## RV dwellers can park on private property in residential areas under new ordinance

**From:** [Tanner, Rachael](#)  
**To:** [David Rogosa](#)  
**Cc:** [Planning Commission](#)  
**Subject:** RE: 985 Channing. Follow-up commentary and materials from Oct 13 deliberations, D Rogosa  
**Date:** Wednesday, November 24, 2021 1:03:59 PM  
**Attachments:** [DRogosaPTC11-10.pdf](#)  
[image001.png](#)  
[image002.png](#)  
[image004.png](#)  
[image005.png](#)  
[image006.png](#)  
[image007.png](#)

DUNLAP RESIDENCE

985 CHANNING AVENUE  
 PALO ALTO, CA 94301

EXISTING & PROPOSED SITE PLANS

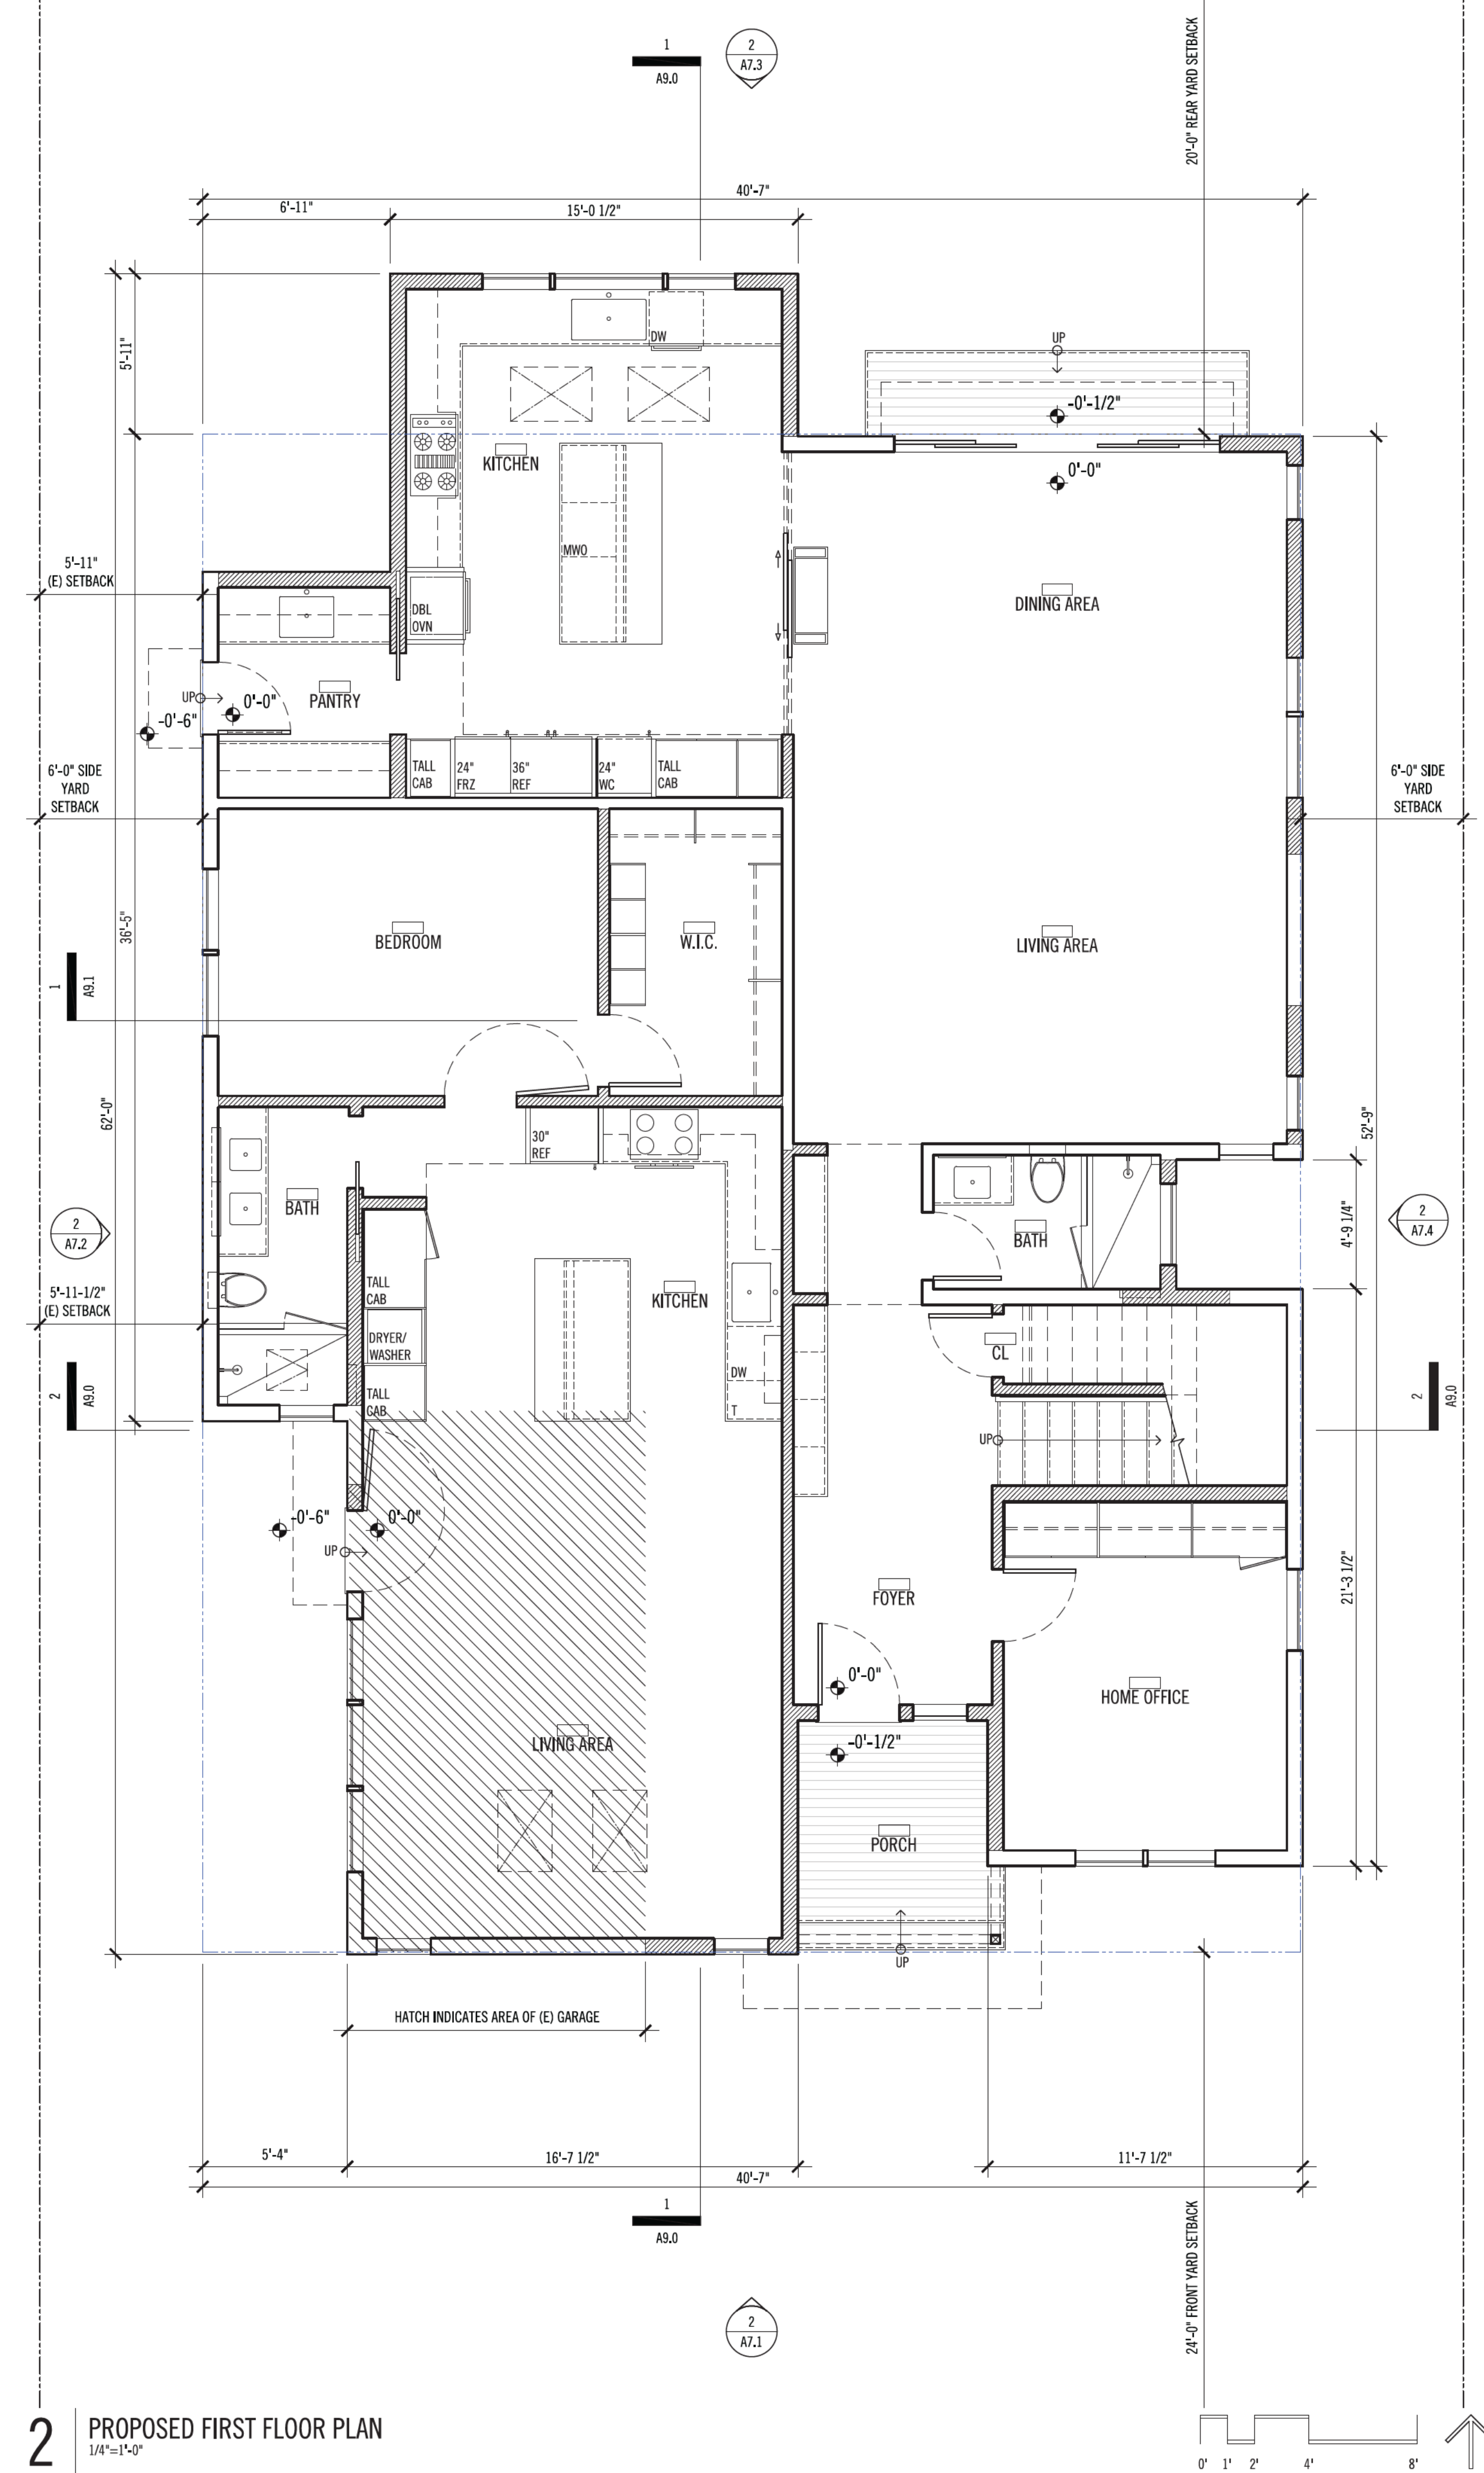
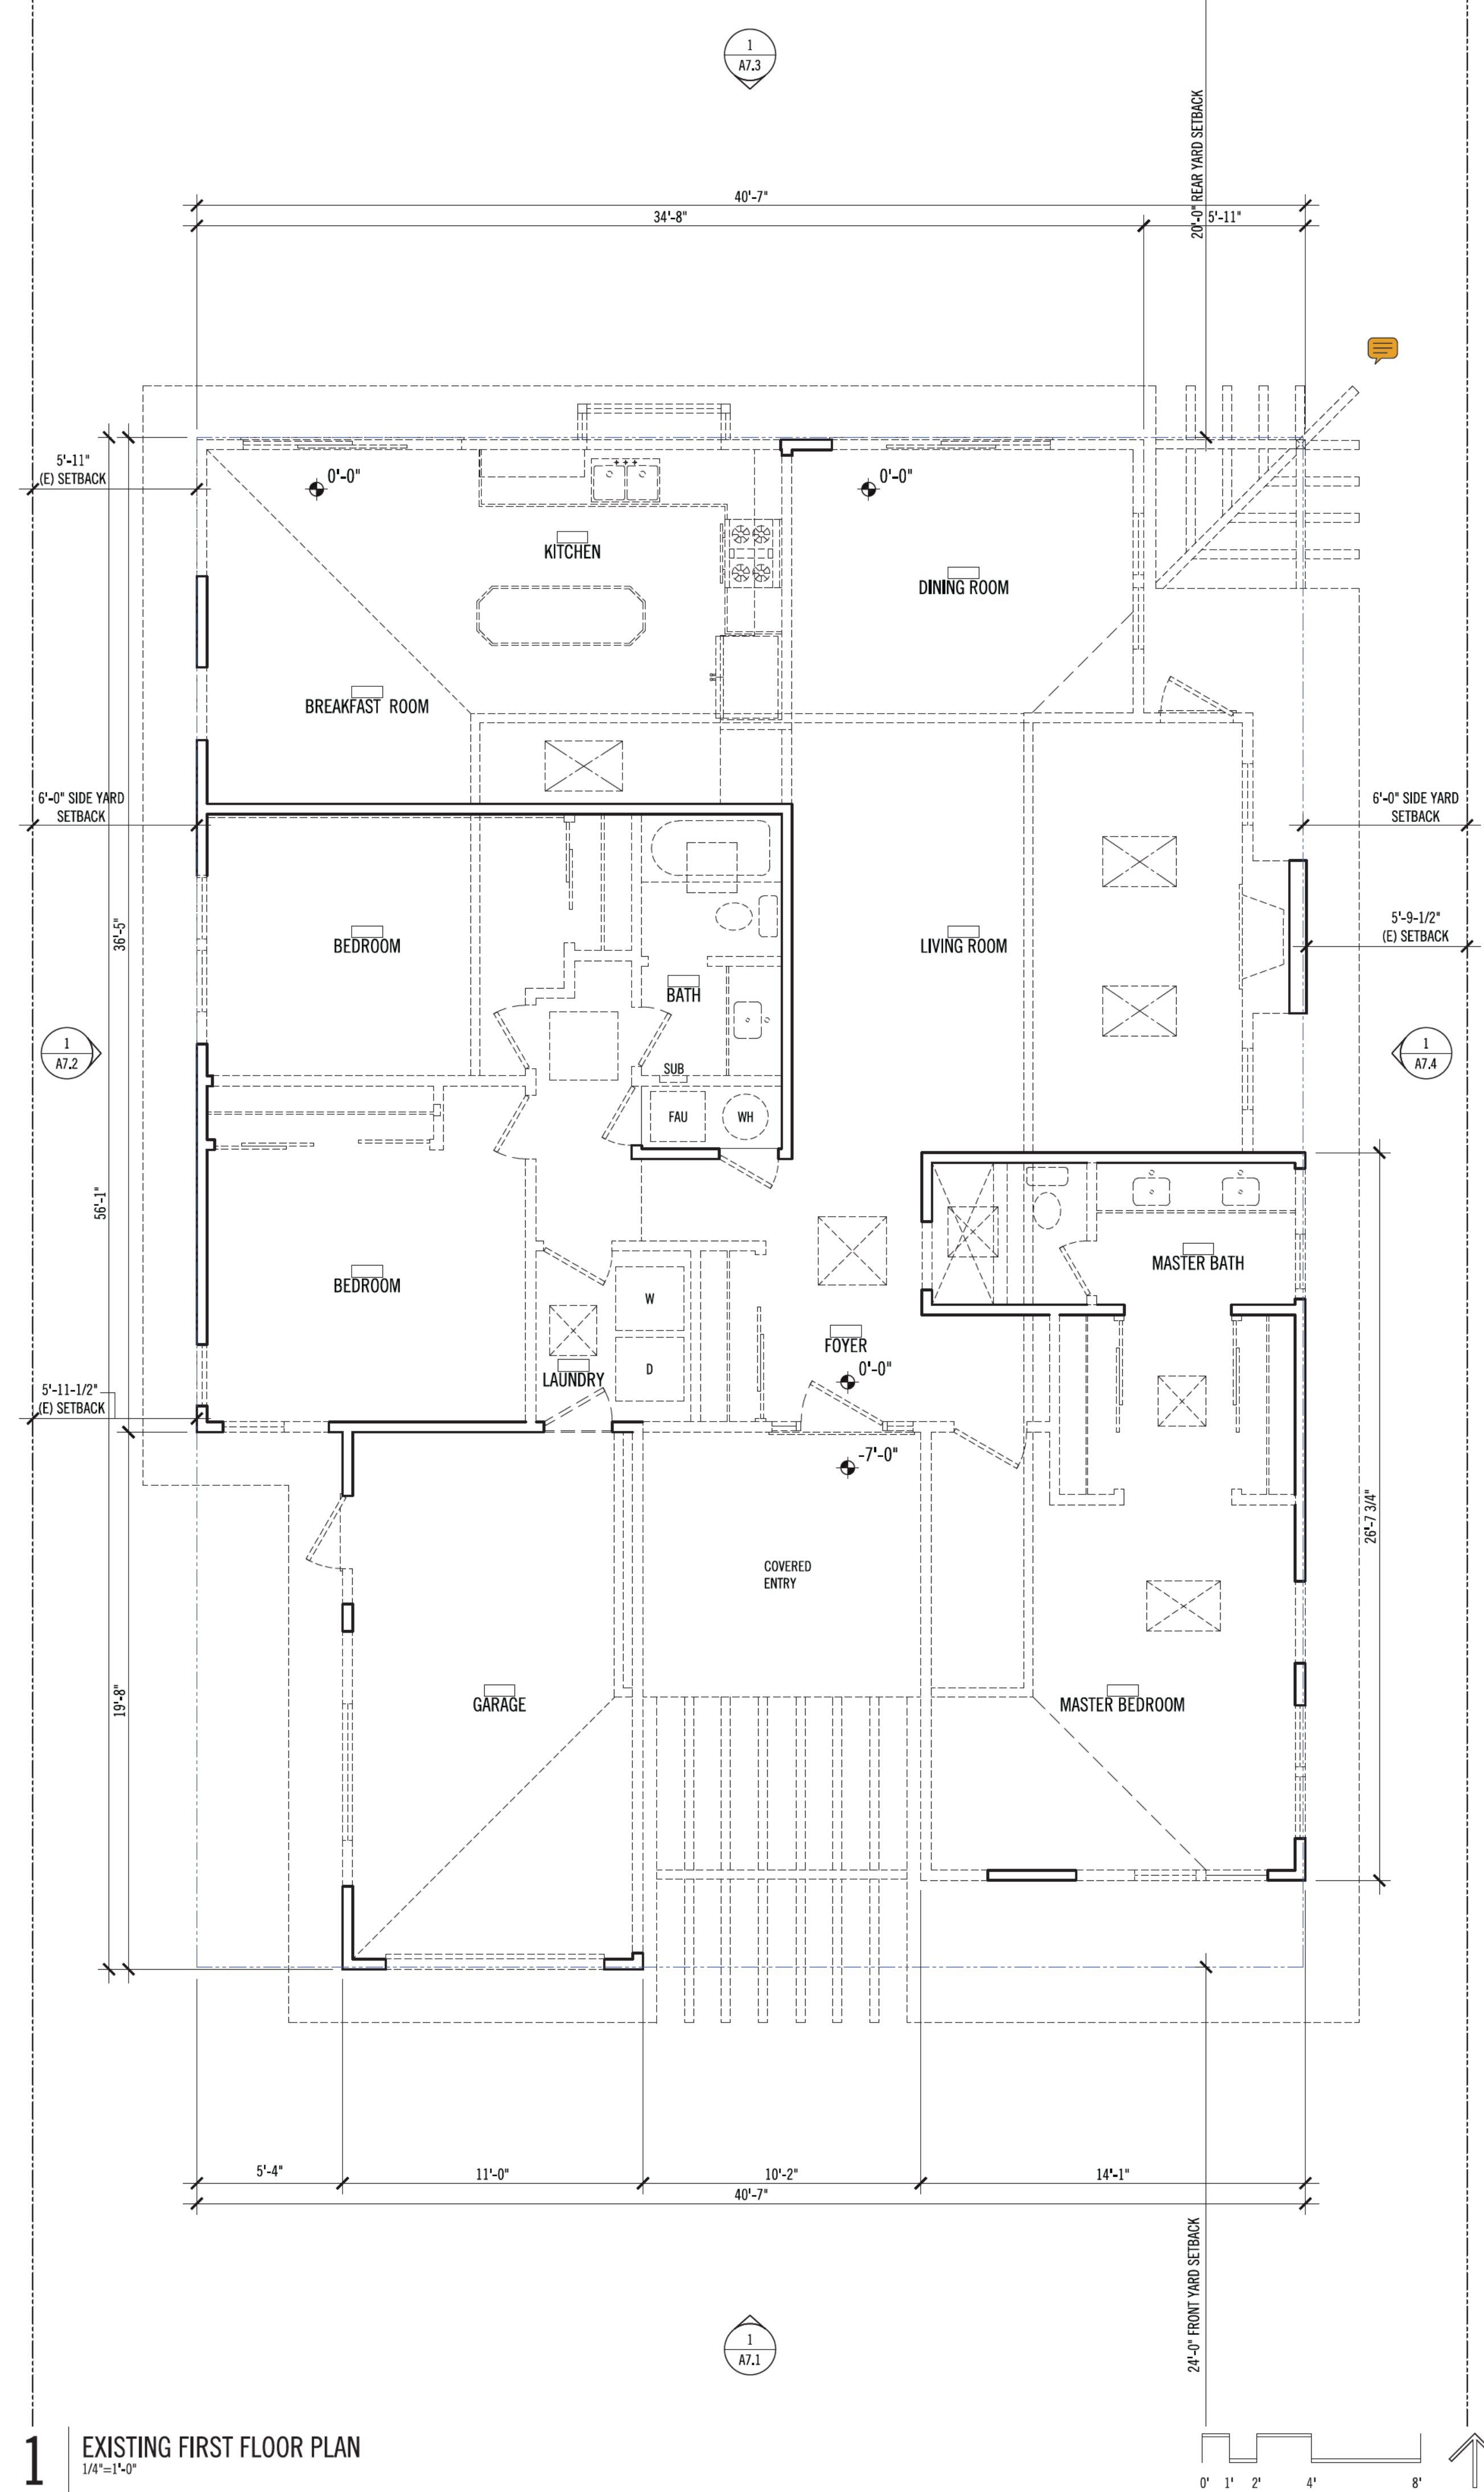
A3.0	Comment	Garrett Sauls : Planning	New fences that are shown to be in disrepair or overhanging on adjacent properties must be replaced. Update the plans to show a new fence will replace the existing one.
A4.0	Comment	Garrett Sauls : Planning	Per the IR checklist, the survey must include information on the Base Flood Elevation required to meet FEMA standards. It is unclear if this information is present. Update the survey and plans to include this information.
A5.0	Callout	Garrett Sauls : Planning	Any uncovered parking provided that is adjacent to a wall must provide an additional .5' of clearance space for door swing. Update the plans to provide this information.
A5.0	Callout	Garrett Sauls : Planning	INCOMPLETE: Update plans to include mechanical equipment to be used. Provide spec sheet and decibel rating of new unit.
A5.0	Callout	Garrett Sauls : Planning	Note driveway material
A5.0	Callout	Garrett Sauls : Planning	Update to show connection lines to house and any proposed utility connections (such as gas or other).

A5.0	Comment	Garrett Sauls : Planning	Per PAMC 18.54, maximum residential driveway widths are 20 feet. Reduce the driveway paving to comply with this requirement.
A5.0	Comment	Garrett Sauls : Planning	INCOMPLETE: Show footprints and overhangs of all existing and proposed buildings. Per PAMC 18.40.070, encroachments, including eaves of buildings, are not allowed within the special setback for the building. Update the plans to address this issue.
A5.0	Comment	Garrett Sauls : Planning	All trees to remain must have tree protection fencing provided for them. Update the plans to show this information.
A5.0	Comment	Garrett Sauls : Planning	The IR checklist requires that all trees species be identified on the plans, including those that overhang the site. Update the plans to correct this.
A5.0	Comment	Garrett Sauls : Planning	INCOMPLETE: Topographic elevation of the first floor level and spot elevations of existing and finished grade around property to determine daylight plane compliance and adjacent to building footprint for height measurement. See pages 26-28 of the Zoning Technical Manual. Additionally, the points provided around the site inaccurately reflect actual topographical elevations from the survey. Correct these.

A5.0	Comment	Garrett Sauls : Planning	Additional screening trees may be required along the left and rear sides of the property to conform with the IR Guidelines. Update plans following recommendations for IR Guidelines.
A5.0	Comment	Garrett Sauls : Planning	Provide a calculation that identifies at least 60% permeability within the front yard setback.
A6.1	Comment	Garrett Sauls : Planning	This house is effectively a brand new structure. Any existing non-conforming walls must be replaced in a conforming condition per 18.70.100. In order to support the proposed additions what walls are claimed to "remain" will ultimately be modified to an extent that they are new.
A6.2	Comment	Garrett Sauls : Planning	Update FAR diagram to provide dimensions for each area.
A7.1	Comment	Garrett Sauls : Planning	INCOMPLETE: Measure the distance under the daylight plane perpendicular to the daylight plane.
A7.1	Comment	Garrett Sauls : Planning	Update materials to identify color to be used for materials.

A5.0	Callout	Arnold Mammarella : Planning IR	IR-1: To meet guideline one, revise the site plan to retain the existing driveway or provide a new driveway no more than 20 feet wide with at least 2 feet planting strip along the fence line with planting. Use alternatives to standard concrete and vary paving material for walkway with a design that integrates the driveway more with the landscape and yard/building entry. See guideline comments for additional discussion.
A5.0	Callout	Arnold Mammarella : Planning IR	IR-2: To meet guideline one and five, revise the site plan to provide landscape, such as medium sized screening trees or tall screening shrubs within side yards between this home and adjacent homes. Where existing landscape exists fill gaps in the landscape. Landscape can also be used to mitigate privacy, but it cannot be the primary means of privacy mitigation where direct sight lines exist to neighboring property. Provide plant choices with botanical names and quantities; indicate 24-inch box size and 8-foot minimum installed height for trees and 15-gallon size and 8-foot minimum installed height for screening shrubs.

INCOMPLETE: Update plans to include mechanical equipment to be used. Provide spec sheet and decibel rating of new unit.

Any uncovered parking provided that is adjacent to a wall must provide an additional .5' of clearance space for door swing. Update the plans to provide this information.

Note driveway material

Update to show

IR-2: To meet guideline one and five, revise the site plan to provide landscape, such as medium sized screening trees or tall screening shrubs within side yards between this home and adjacent homes. Where existing landscape exists fill gaps in the landscape. Landscape can also be used to mitigate privacy, but it cannot be the primary means of privacy mitigation where direct sight lines exist to neighboring property. Provide plant choices with botanical names and quantities; indicate 24-inch box size and 8-foot minimum installed height for trees and 15-gallon size and 8-foot minimum installed height for screening shrubs.
